# UNIVAIR AIRCRAFT CORPORATION

UNIVAIR MANDATORY SERVICE BULLETIN LPC-1: Amend. A  
Supersedes Service Bulletin LPC-1, Dated October 24, 1995  
DATE: SEPTEMBER 17, 2004

SUBJECT: Mandatory Landing Gear Product Improvement

APPLICABILITY: Piper PA-22 aircraft modified to taildragger configuration using STC-SA45RM.

**View Looking Aft  
Right Hand Gear Shown**

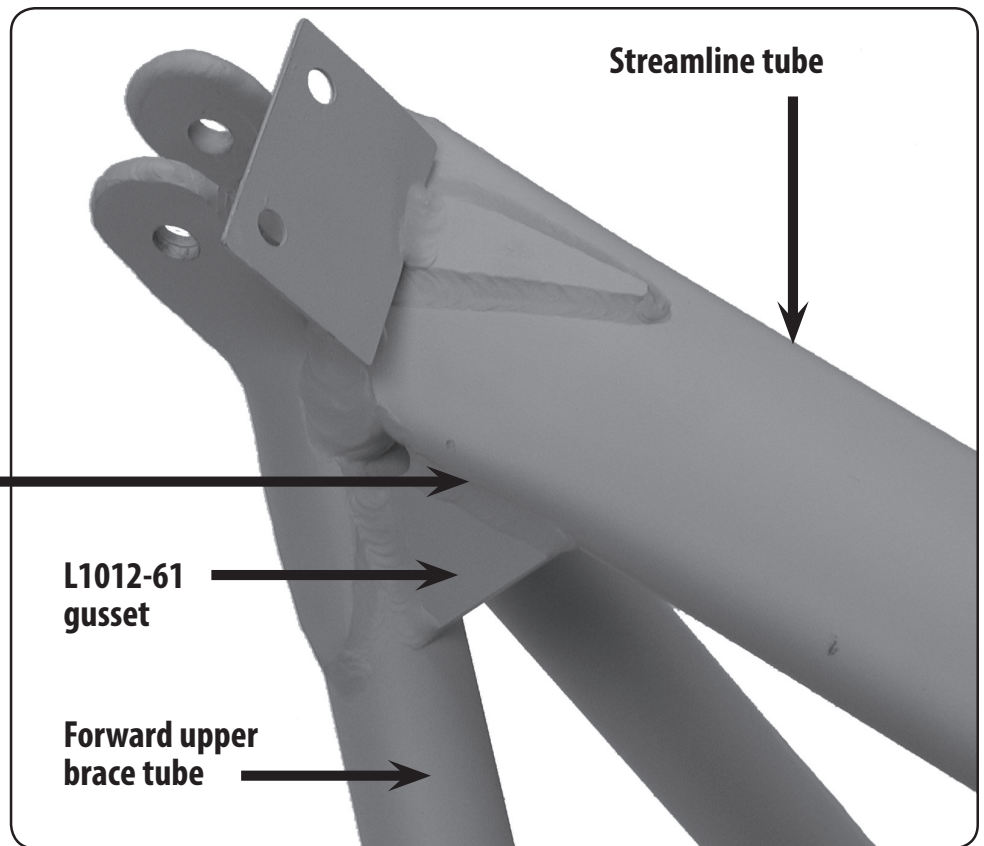
To preclude the possibility of failure at the upper shock strut-drag tube area of the LPC 1012 series landing gear vees used in the STC-SA45RM taildragger modification a second gusset has been added to the upper end of the streamline brace tube. This new gusset is welded between the forward edge of the streamline tube and the forward upper brace tube near the hydrasorb attach socket (see detail drawings for exact location). The addition of this gusset, P/N L1012-61 will preclude the possibility of landing gear failure and other possible damage to the aircraft. Gear vees with two gussets at the upper end of the streamline tube were produced after January 25, 1990 or have already been modified per the 1995 bulletin and are not affected by this bulletin.

In addition to the gussets, the weld beads between the streamline tube and the upper brace tubes should be extended as far as possible on the leading edge and built up on the trailing edge as shown in the detail drawings. To reduce fire danger, the airplane should be properly supported and the gear vees removed from the aircraft to perform all welding operations. Inspect the gear and gear attach fittings while it is removed for any indication of wear, cracks, or damage. Repair any unairworthy conditions prior to returning aircraft to service. Touch up paint as required prior to gear vee installation.

**Weld approximately  
1/16" – 1/8" from edge  
of streamline tube.**

**End View**

**Right Hand Gear Shown**

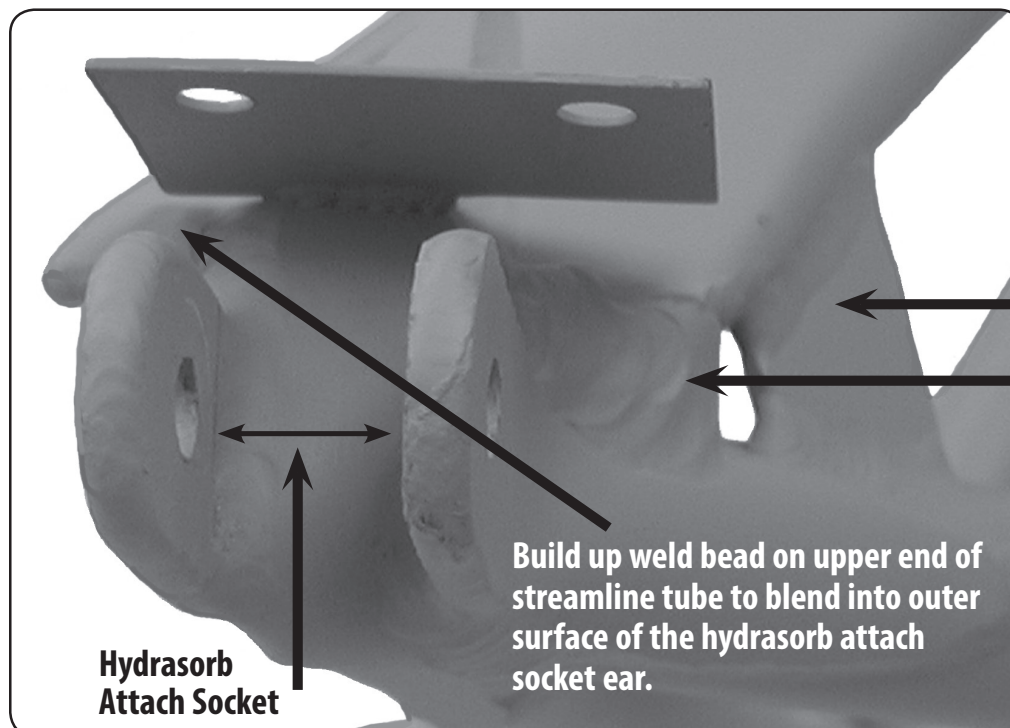
Univair will supply at no charge, upon request, two gussets P/N L1012-61 which should be welded onto the affected gear vees in accordance with AC43.13-1B Chapter 4, Section 5. Refer to the detail drawing for location and welding requirements. For more information or to obtain gussets, please contact Univair at 303-375-8882 or FAX 303-375-8888.

**L1012-61 gusset**

**Extend this weld bead as  
far as possible between  
streamline tube and  
forward upper brace tube.**
